Ten unanswered questions about the IBR Freeway widening project

Testimony to the Joint Interim Committee on the I-5 Bridge

Joe Cortright May 20, 2022

The Oregonian, Page 1, January 11, 2014, reporting on ODOT's own analysis

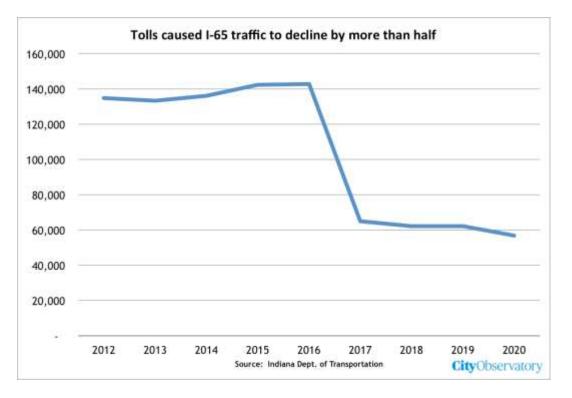
Technical work done for the CRC project, reported on page one of the Oregonian in 2014, indicated that tolling I-5 would produce gridlock on I-5.

CRC to push gridlock east

A new, tolled I-5 bridge will lead to a big jump in traffic on the I-205 span, a report says

A report says that if the interstate 5 bridge (left) is replaced by a toiled Columbia River Crossing, daily traffic on the interstate 205 bridge (left) is projected at 295,300 - 42,900 vehicles more than if the CRC were not built. That level of traffic would push the I-205 span to its capacity.

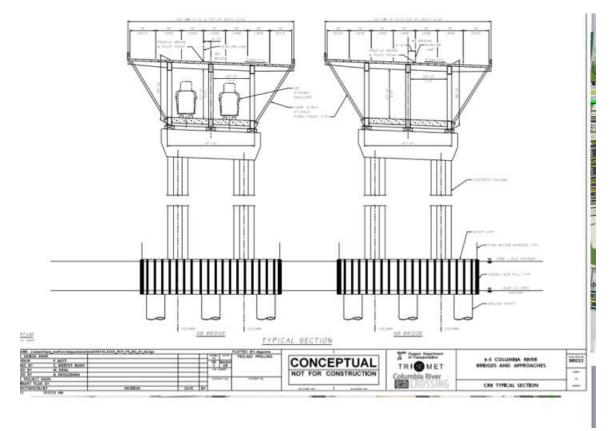
The I-5 bridges reached capacity almost two decades ago, and can't handle additional traffic, but ODOT's model apparently predicts that traffic will continue to grow across the bride even though there's no capacity. This is a classic example of a broken model that in the words of national modeling expert Norm Marshall "forecasts the impossible." ODOT's own consultants, CDM Smith, said in 2013 that the I-5 bridge could handle no more peak traffic due to capacity constraints:

Traffic under the existing toll-free operating condition on the I-5 bridge reached nominal capacity several years ago, especially considering the substandard widths of lanes and shoulders on the facility. The I-5 bridge has little or no room for additional growth in most peak periods, and capacity constraints have limited growth over the last decade.

The IBR's own modelers admitted that traffic growth on I-5 has been limited due to the bridge being at capacity and congested. Yet they've created a fictitious "no build" scenario in which traffic continues to increase, essentially because it has no meaningful feedback loops to adjust travel demand to reflect how humans actually respond in the face of congestion.

Real Answer: ODOT is using flawed models that overstate no-build traffic and pollution, and conceal the true environmental impact of freeway expansion

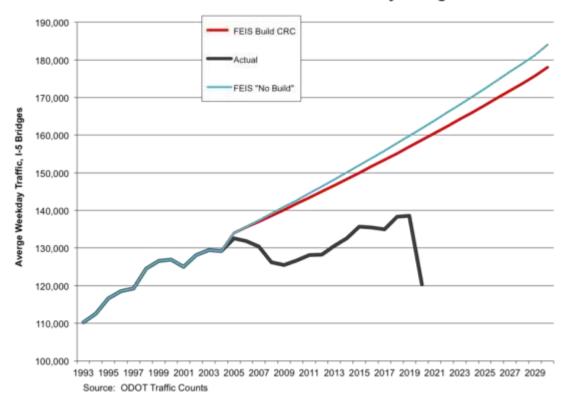
The IBR team describes the I-5 Bridges adding either two or four so-called "auxiliary lanes" to the existing six freeway lanes on I-5 through the project area. But the project hasn't revealed how wide the structures are that its actually building. In the project's last iteration, the "Columbia River Crossing", the project said they reduced the size of the bridge from twelve lanes to ten in response to objections to its width from local leaders, but in fact, public records requests showed that they didn't reduce the physical size of the bridges (or other structures) at all. The supposed "ten lane" bridge was 180 feet wide, just as was the proposed "twelve lane" bridge.

The cryptic information provided by the IBR says that its so-called 10-lane bridge would be just as wide as the CRC (180 feet), and the so-called 8 lane bridge ("one auxiliary lane") would be just 16 feet narrower ("2013 LPA Minus 16 Feet"), which works out to 164 feet wide. With standard-width 12 foot wide freeway lanes, this 164 foot wide bridge would accommodate ten traffic lanes (120 feet), with 11 foot shoulders on either side of the travel lanes, or as many as twelve travel lanes (144 feet) with five foot shoulders on either side of the twelve travel lanes). (Alternatively, the 164 foot width would allow construction of 12 travel lanes with 2 foot wide left shoulders and 8 foot wide right shoulders, which would be common, if not generous for an urban bridge).

When it comes to bridges or freeway capacity, ignore how many "lanes" ODOT and WSDOT claim they're building, and look at how wide the structures are. They've repeatedly used this deceptive tactic to intentionally conceal the true width and environmental impact of their projects.

Real Answer: Regardless of how many lanes IBR claims it is building, its actual plans provide capacity for more, in this case a 10 or 12 lane bridge.
